STATE OF NEBRASKA DEPARTMENT OF ROADS ADDENDUM NO. 2 AND

AMENDMENT NO. 2 PROJECT NOS. NH-80-9(832), NH-80-9(825) & NH-80-9(827) CONTROL NOS. 12450A, 12452 & 12454 CALL ORDER 100

> I-80, MAHONEY TO GREENWOOD LETTING DATE: JANUARY 23, 2009

Sheet 2-N5

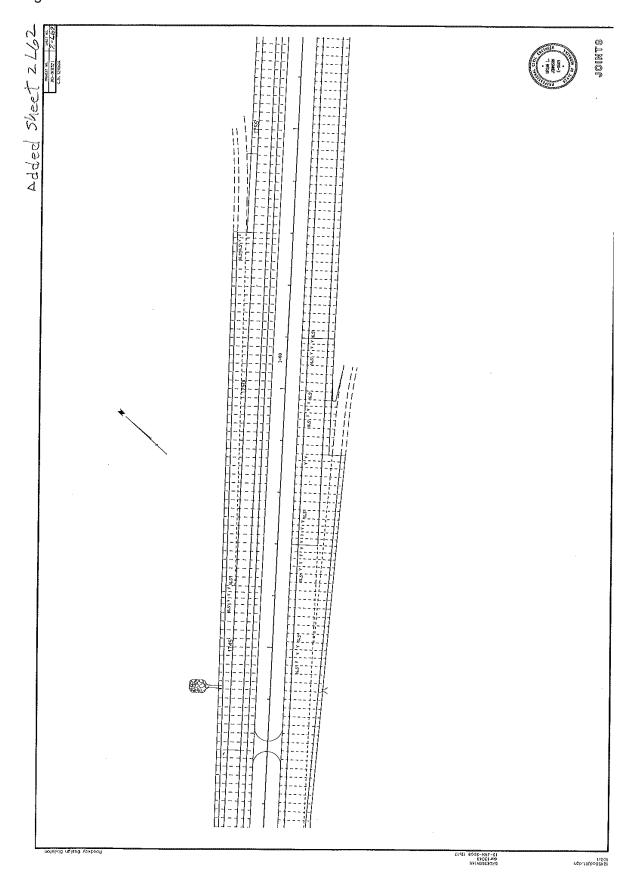
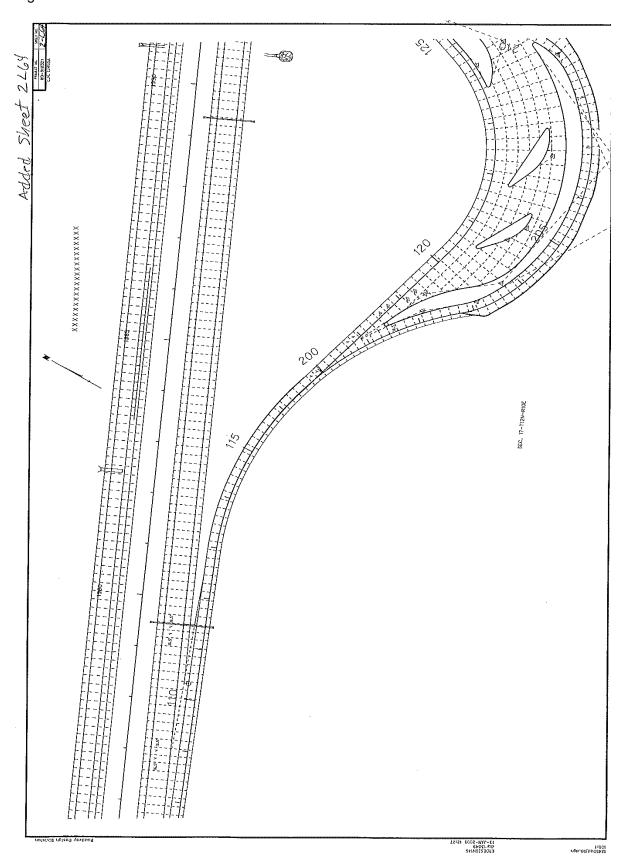
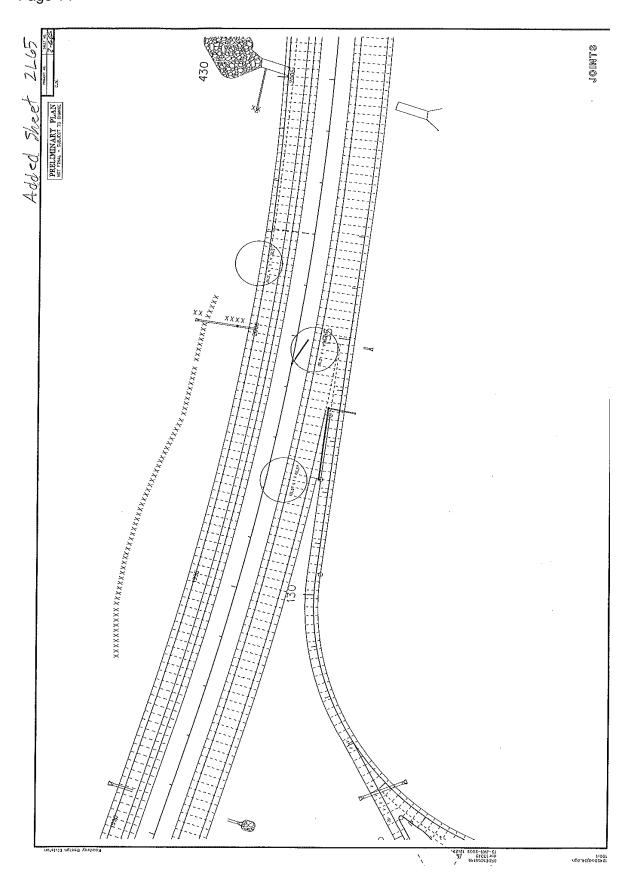
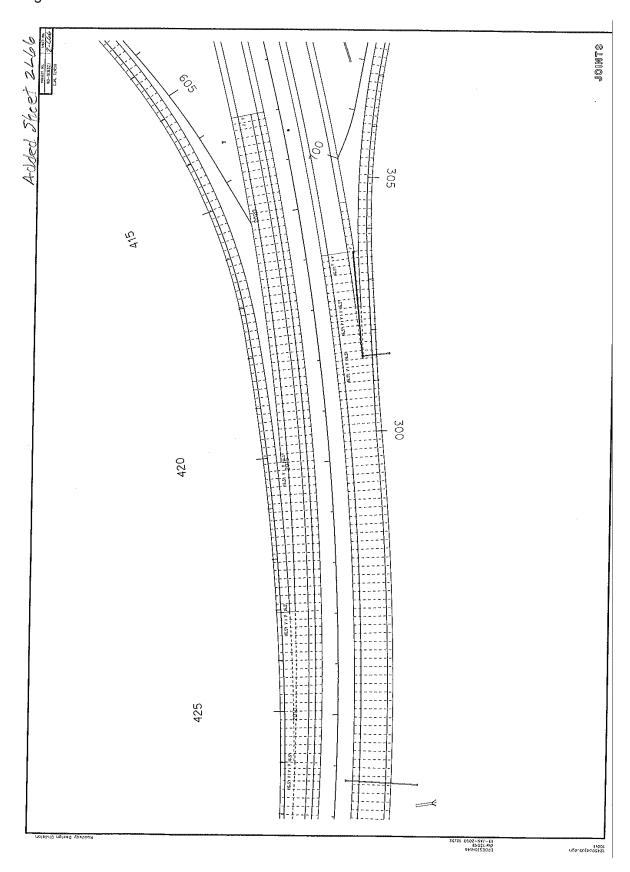
On plan sheet 2-N5 for Project NH-80-9(832), the following changes are made:

1. In the ASPHALT CONCRETE, TYPE SPL (TEMP.) table, the quantity for Phase 1B is amended to read:

16,553 SY *

- * Includes 3,600 SY of Asphalt Concrete, SPL, for a third contractor access. Two contractor access locations are shown in the plans. The third access location (3,600 SY) may be constructed at a location determined by the contractor and approved by the Engineer. This third location is not shown in the plans and is not included in the Remove Asphalt Surface quantity.
- 2. The 10" CONCRETE PAVEMENT (TEMP.) table is amended to read:

PHASE	SQ. YDS
2A	2690
2B	4973
TOTALS	7663

3. The EARTHWORK QUANTITES table is void and superseded by the table depicted on the attached sheet.
